FINAL PRODUCT/PROCESS CHANGE NOTIFICATION #20467Generic Copy

Issue Date: 07-May-2014

TITLE: LAN Switch Devices in wQFN 42 & 56 pin (Gold Wire).Qualification at ASE-Shanghai and AMKOR-Philippines Assembly Facilities.

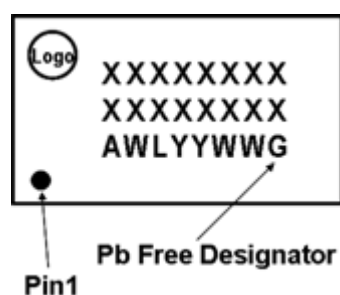
At the expiration of this FPCN devices can be assembled in the existing facilities or ASE, Shanghai or Amkor, Philippines. Devices assembled in the new facilities will have date code of WW32 (July 28), 2014 or later. AMKOR and ASE facilities will follow the ON Semiconductor standard marking for wQFN with package dimensions of 3.5mm x 9.0 mm, 5.0mm x11.0 mm, 6.0mm x6.0 mm, 10mm x 10mm.

Marking shall be "Standard Specification for Integrated Circuits".

Line 1: is the core part number such as NCN7200

Line 2: is lot number information

Line 3: is Date Code with a lead free designator of "G" at the end of the label.
